PIC18F87J50 Family Silicon Errata and Data Sheet Clarification

The PIC18F87J50 family devices that you have received conform functionally to the current Device Data Sheet (DS39775C), except for the anomalies described in this document.

The following typographic corrections and clarifications are to be noted for the latest version of the device data sheet (DS39775C):

FIGURE 19-10: I²C™ SLAVE MODE TIMING (TRANSMISSION, 7-BIT ADDRESS)

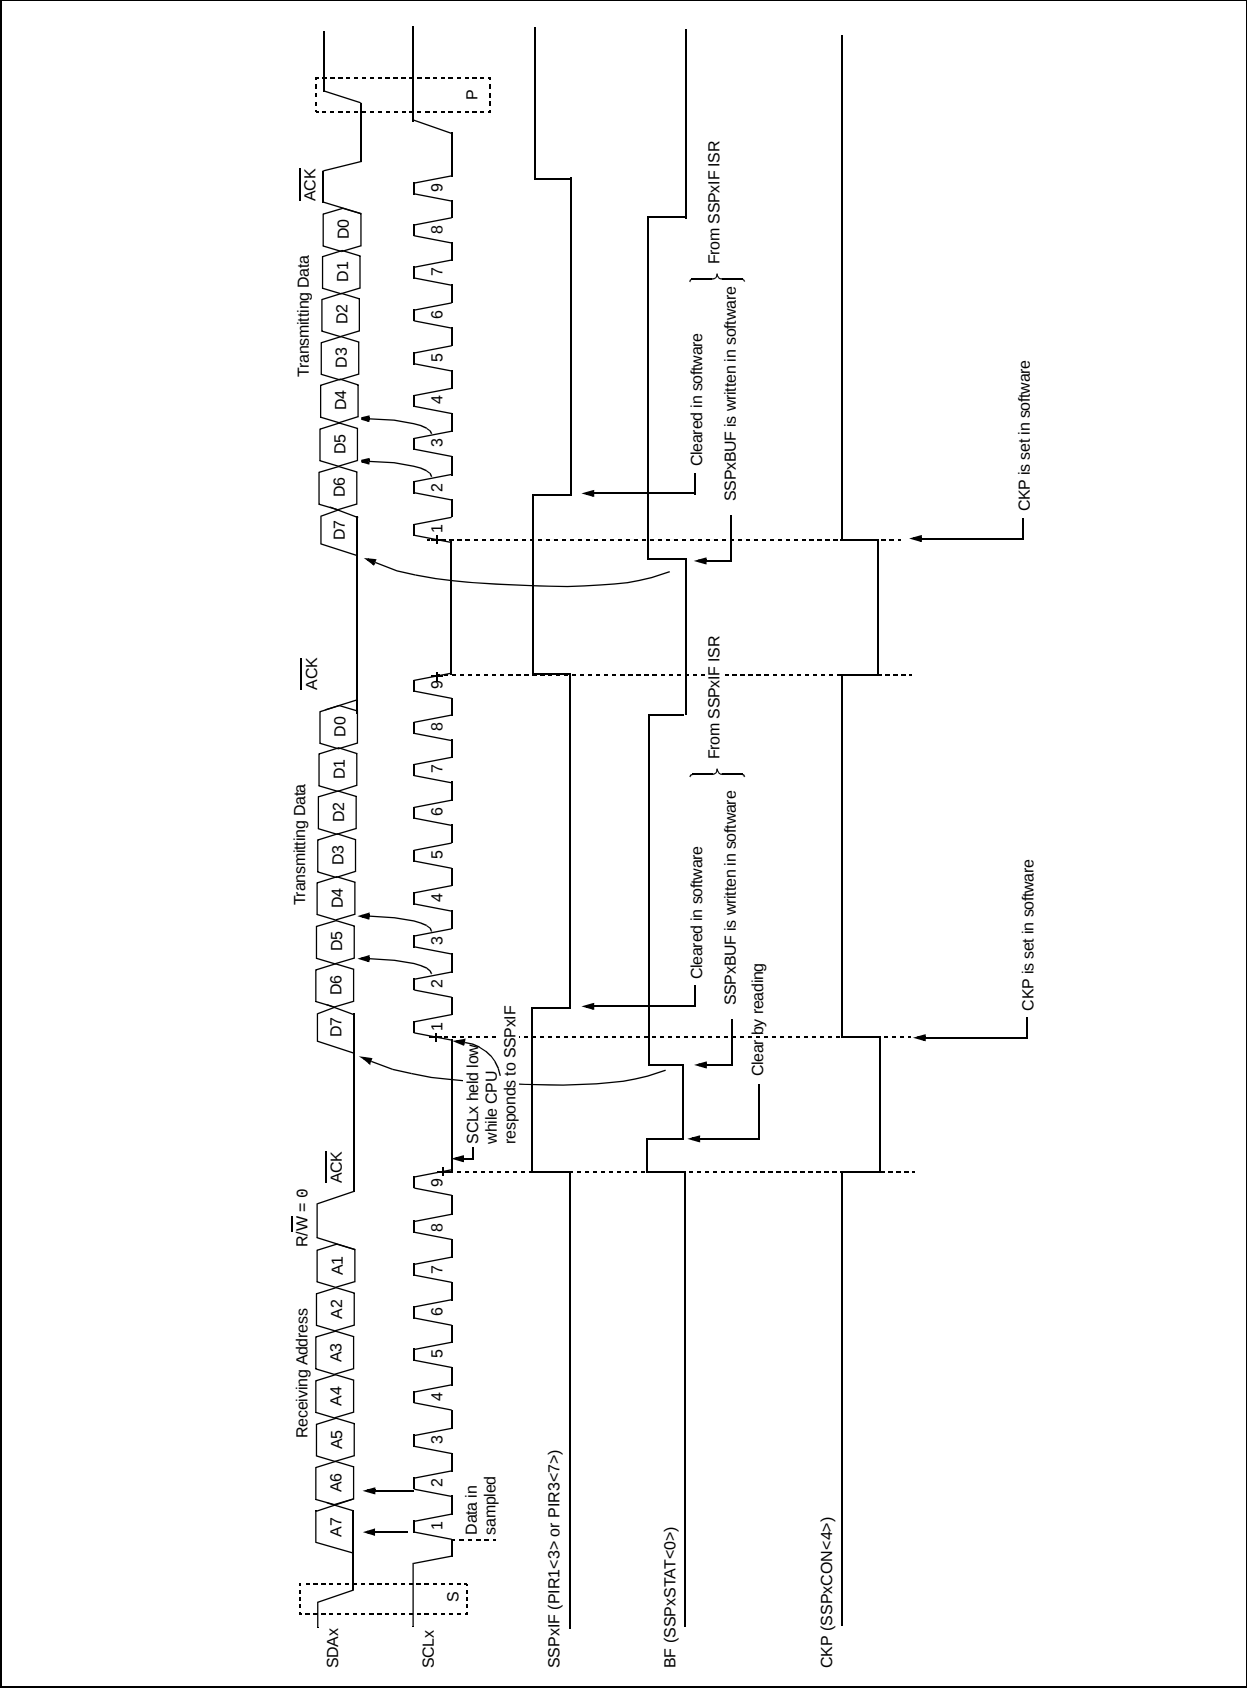
6. Module: Figure 19-10: I²C™ Slave Mode Timing (Transmission, 7-Bit Address)

On page 252, the figure is replaced with the new timing diagram provided in [Figure 19-10](#).
